STAFF REPORT: MARCH 12, 2025 MEETING

APPLICATION NUMBER: HDC2025-00069

ADDRESS: 1090 VINEWOOD

SCOPE: ERECT ROOFTOP ADDITION/DORMERS

Above right: Staff photo looking southeast from the sidewalk. February 2025. This vantage point offers greater visibility of the proposed north dormer.

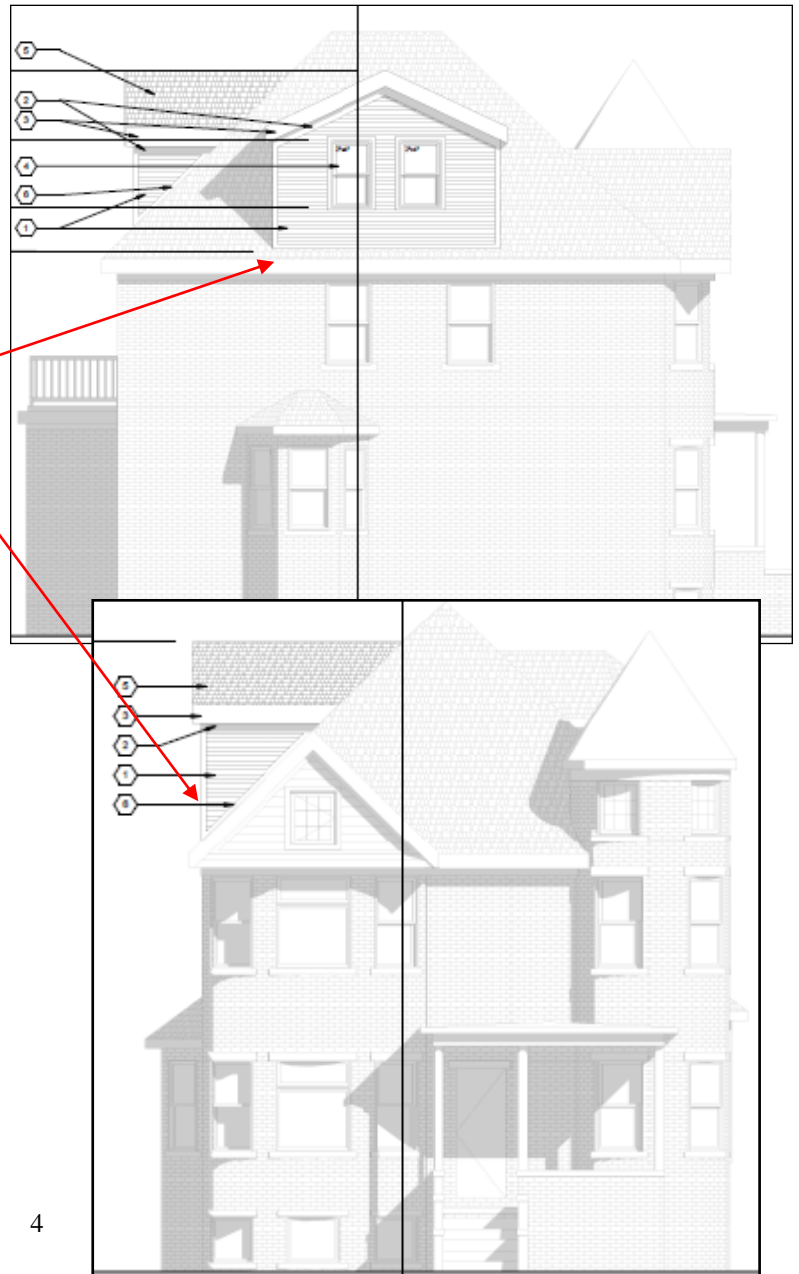
- Staff finds some of the design features proposed for the north dormer to be incompatible with the house, specifically related to its placement, roof style and window openings -- the dormer should be a secondary feature against the historic dwelling's massing.

- The north elevation drawing shows the front wall of the dormer set in slightly from the roof's edge, but the façade's elevation drawing shows this minimal setback aligns the dormer wall with the house's north wall, making it look as if the dormer is a physical extension of the house.

- Further recessing the dormer's primary wall will allow the new construction to clearly read as a dormer, rather than as an extension of the house.
- The two separate window openings should be combined into a single mullied unit, which is a common design feature for window openings on a historic building when there are multiple windows within a small wall surface. A factory-mullied double-window would be a contemporary, compatible option.

- The north dormer will be recessed a minimum of an additional 12-inches from the wall of the historic house, and the roof design for the north dormer will be changed from gable to hip.
- Aluminum-clad wood double-hung, one-over-one windows will be selected, and the window openings will be modified to become a centrally placed and factory mulled, two window opening.
- Wood lap siding will be used on the walls of both dormers. Dimensions confirming the exposure and siding profile will be submitted for staff review.
- The scope of work, drawings and cut-sheets will be revised and submitted to staff for review.

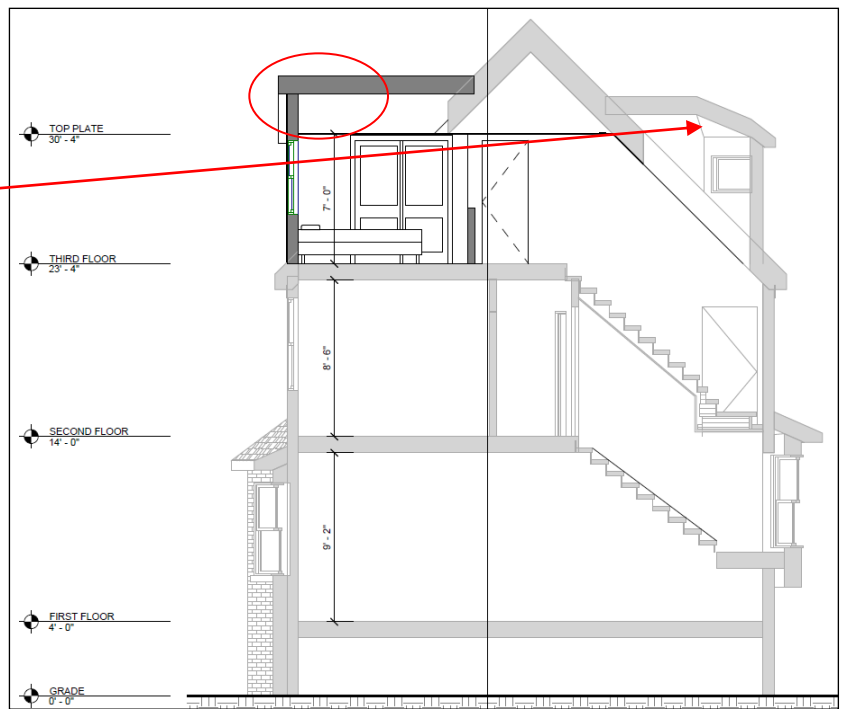
- Using a hip roof (rather than the suggested gable) would echo the angular profile of the house's hip roof and match the profile of the southern roof line of the historic dormer. This would reduce the visual impact of the dormer while allowing the applicant to retain the majority of the requested interior vertical space.

Applicant drawing -- Building section, looking through the dwelling from south to north. The east/rear wall is at the right side of the drawing; the dark thick lines illustrate the proposed roof and wall placement for the rear dormer.

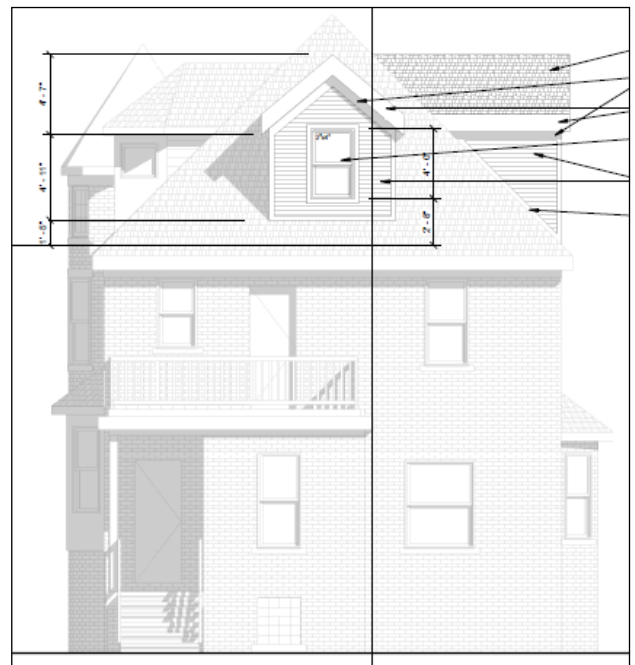
- Staff does not have similar concerns with the placement and roof design for the rear/east elevation dormer. The recessed location of the dormer aligns with staff's previous recommendations for appropriate design and placement of dormers, and the gable roof with matching pitch of the historic hip roof doesn't compete against, but rather mimics, the existing roof shape and building massing at this rear location.

Applicant drawing – Rear elevation. The placement of the dormer is proportional to the surface area of the roof. The dominant view of this dormer will be from the rear, therefore the primary profile of the dormer's gable roof matches that of the hip roof (in contrast to the dominant side view of the north dormer).
